No. EC155-04A014

ALERT SERVICE BULLETIN

LIMITATIONS - Control rod double bearing Tail Gearbox (TGB)

The purpose of revision 8 of this ALERT SERVICE BULLETIN is to extend the calendar limit to replace the TGB from December 31, 2024 to December 31, 2028.
It is not permitted to fly with the TGB PRE MOD 07 65B63 from 1st January 2029.

Figure 1: Example of abrasion on the magnetic plug

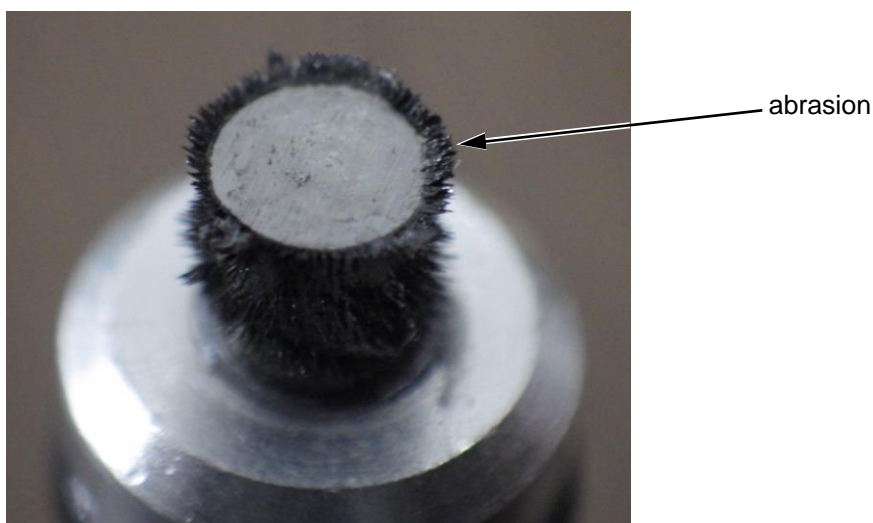
IN THE FLOW CHART, THE ABRASION PARTICLES (CLASS g AS PER MTC) MUST BE TAKEN INTO ACCOUNT IN ADDITION TO THE PARTICLE TYPES USUALLY TAKEN INTO ACCOUNT.

Figure 2

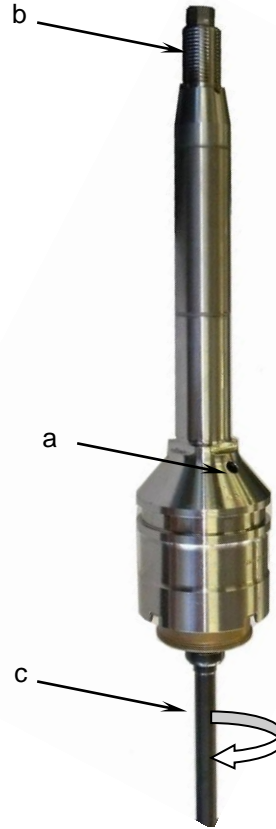
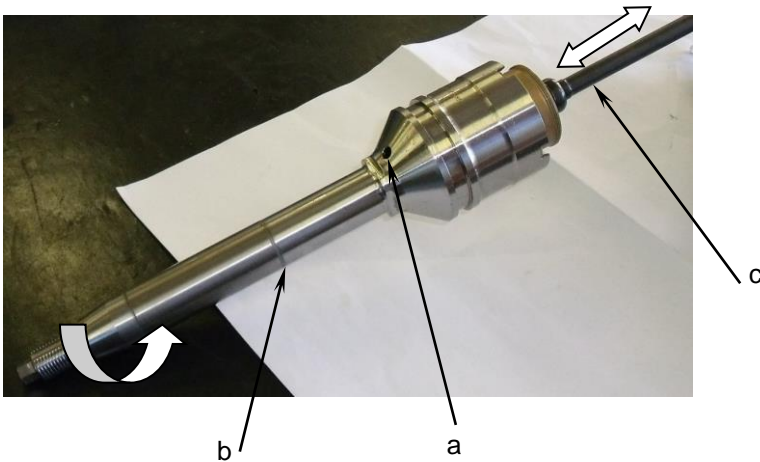
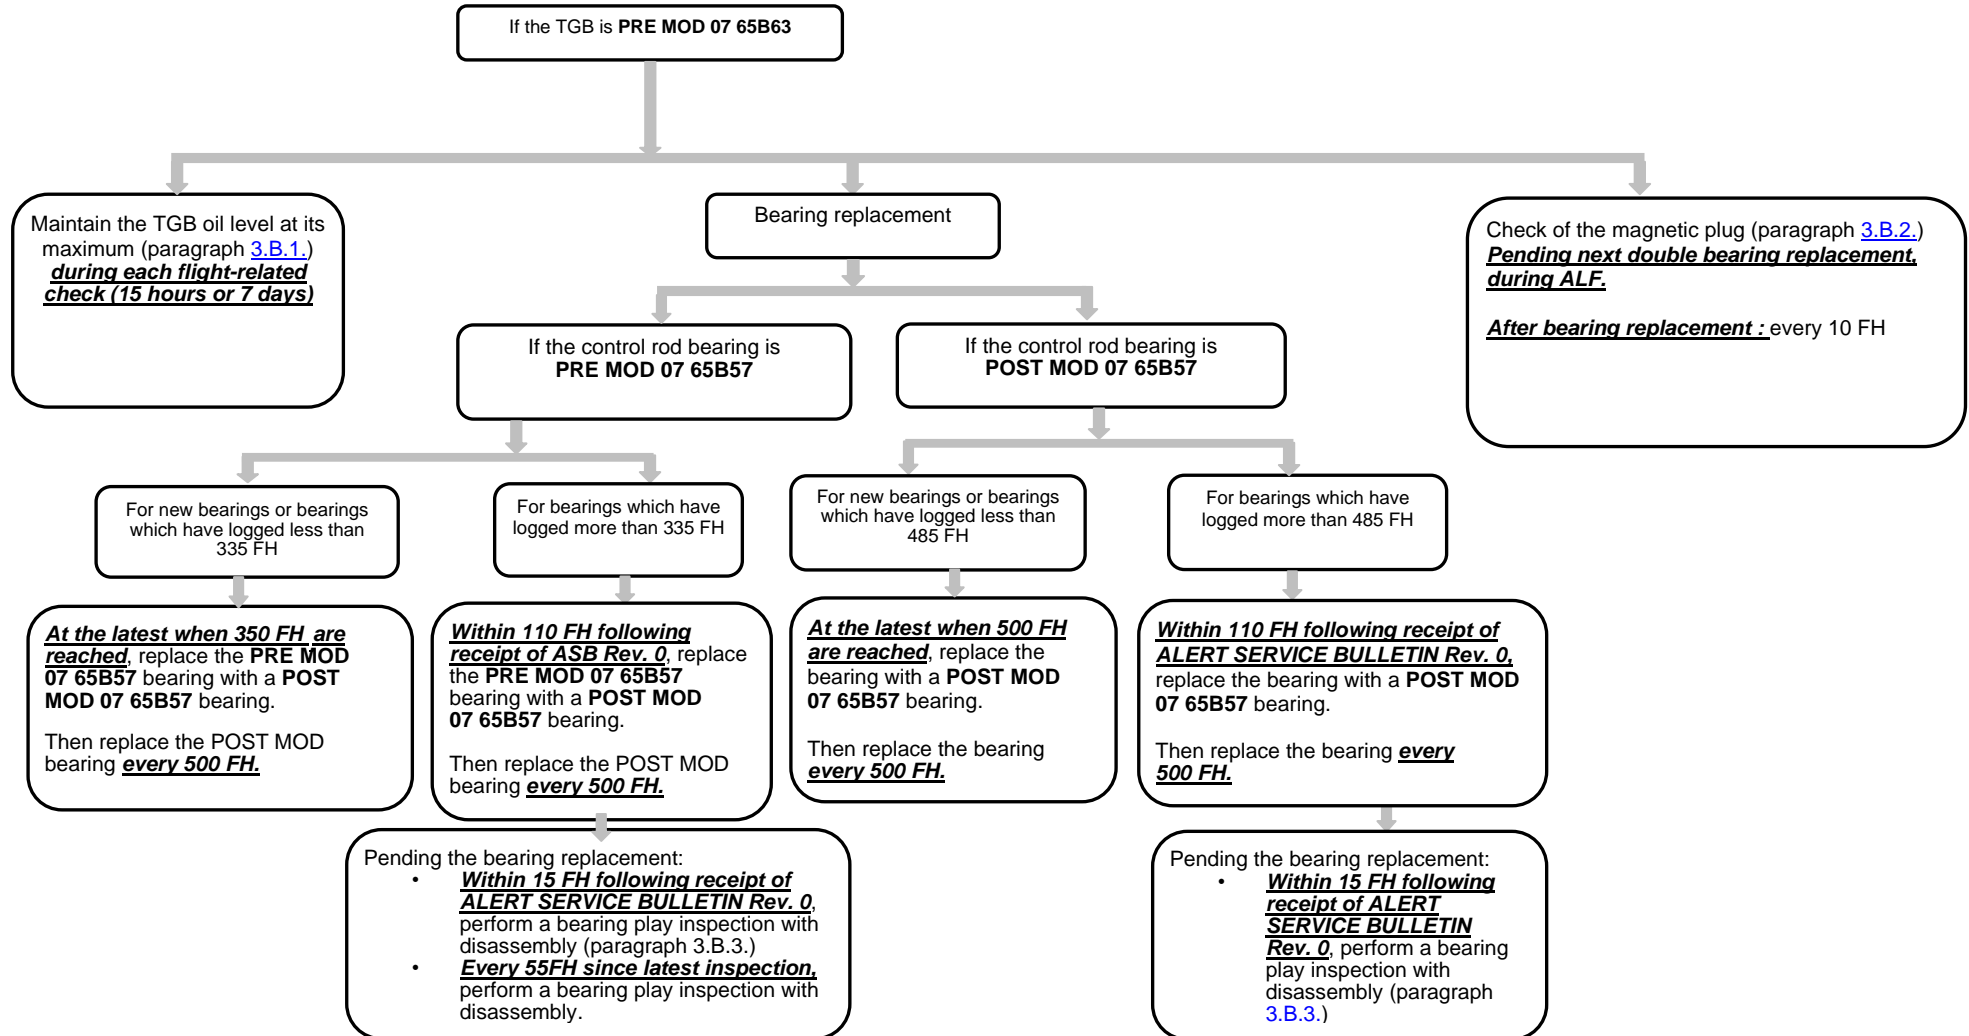
3.B.3. Checking the play in the double bearing of the TGB control shaft/rod assembly ([Figure 2](#))

- Remove the control shaft/rod assembly as per paragraph 3.B.4.a.
- Carry out a tactile check to ensure that there is no axial play in double bearing (d) (Figure 1):
 - . Apply an alternating manual axial load to control rod (c) whilst turning control shaft (b) (**See [DETAIL A Figure 2](#)**).

- Clean the control shaft/rod assembly using WHITE SPIRIT (2) as per Work Card 20-04-01-102 (MTC):
 - 1) Inject WHITE SPIRIT (2) under pressure (for example using a can) into hole (a) of control shaft (b). (**See [DETAIL B Figure 2](#)**).

- . Hold shaft (b) in the vertical position pointing upwards.
 - . Manually turn control rod (c) several times to rinse double bearing (d) by draining the WHITE SPIRIT (2) through the bearing. (**See [Detail B Figure 2](#)**).

- 2) Insert WHITE SPIRIT (2) (for example using a can) in the area of the control shaft (b) that must be cleaned. (**See [DETAIL C Figure 2](#)**).
 - . Manually turn the control rod (c) several times to wash the double bearing (d) by draining the WHITE SPIRIT (2).

Make sure that the area pointed out in [DETAIL C Figure 2](#) is clean.
